Planning Commission Minutes
January 11, 2024

12. (PUD-1987) Application by Shaz Investment Group, LLC to rezone 5101 South County Line Road from PUD-1839 Planned Unit Development District to PUD-1987 Planned Unit Development District. Ward 3.

STAFF REPORT
The City of Oklahoma City
Planning Commission
January 11, 2024

(PUD-1987) Application by Shaz Investment Group, LLC to rezone 5101 South County Line Road from PUD-1839 Planned Unit Development District to PUD-1987 Planned Unit Development District. Ward 3.

PUD-1987
EXHIBIT B

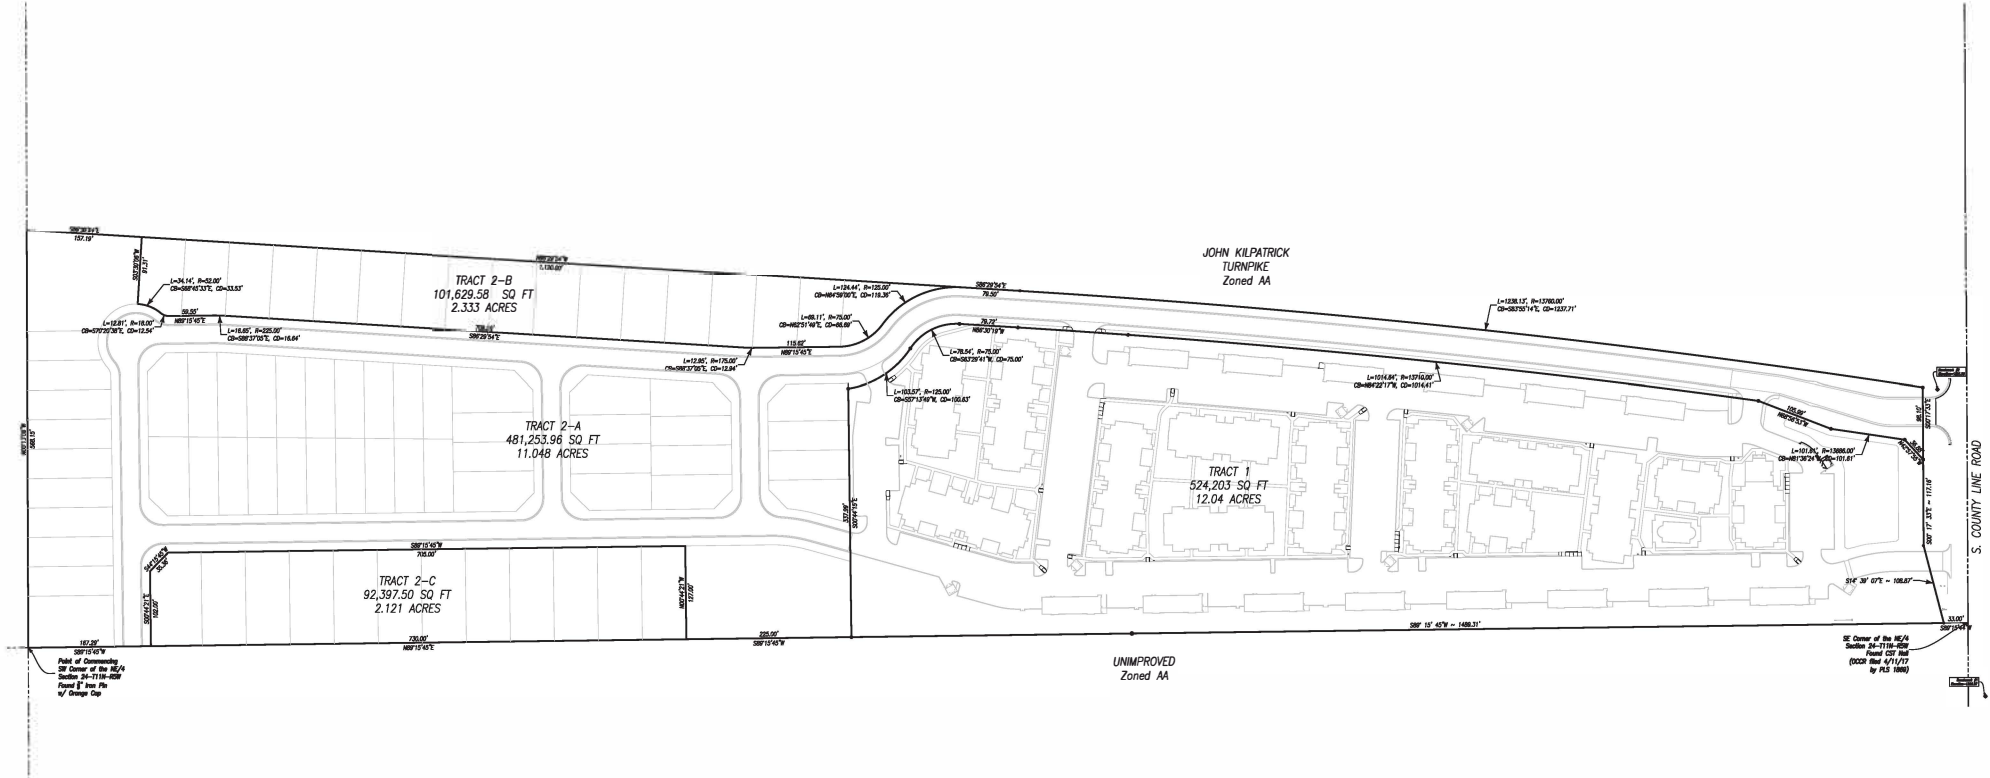
The density requested is slightly higher than that approved in PUD-1839 increasing density from less than 6 du/acre to approximately 6.44 du/acre. The combination of housing product requested according to Exhibit B would be 56 dwellings within duplexes and 44 small-lot single family dwellings. The preliminary plat for PUD-1839 was approved in 2021 as Babol Heights with 89 small-lot single-family dwellings.

Primary access to the development will be shared from one new street. A gas line easement at the southern end of the development prevents another street from providing more street circulation from S. Council Road. The PUD proposes emergency access through the parking lot of the apartments. The street proposed to serve the development does not align with the platted SW 51st across S County Line Road, but will be required to meet the required offset. In addition, PUD-1839 required a connection to the south. PUD-1987 omits the requirement for the southern connection but shows the connection on the PUD Exhibit B. Language from PUD-1839 that requires the southern street stub and that provide eventual connection westward to S Morgan Road and the Turnpike should be added to PUD-1987.

The PUD would rezone only the west portion of PUD-1839, including a connection to S County Line Rd, in order to allow an intermix of duplexes and single-family dwellings. This change would increase the allowed number of units from roughly 89 to 100, if half of the units are duplexes. The PUD also requests to decrease the minimum lot size from 4,000 square feet to 3,500 square feet. The PUD does not provide increased connectivity beyond that required in PUD-1839. About 20,000 square feet of open space, including 13,000 square feet of useable space, is required by the subdivision regulations. The PUD does not address where the open space will be located. Plan conformance would be increased if the PUD added a section on open space, stated that

it will be centrally located to all dwellings in the development and that it will contain large shade trees.

1. Modify Master Design Statement to require a street stub to the south.
1. ~~A minimum of 10 percent Open Space shall be provided within the PUD area. Open space shall be centrally located and include shade trees. Open space shall consist of total 67,584 sf with 24,793 sf dedicated to useable open space.~~
2. Electronic Message Display (EMD) and non-accessory signs/billboards are prohibited.

- 1.** Modify Master Design Statement to require a street stub to the south.
- 2.** A minimum of 10 percent Open Space shall be provided within the PUD area. Open space shall be centrally located and include shade trees.
- 3.** Electronic Message Display (EMD) and non-accessory signs/billboards are prohibited.
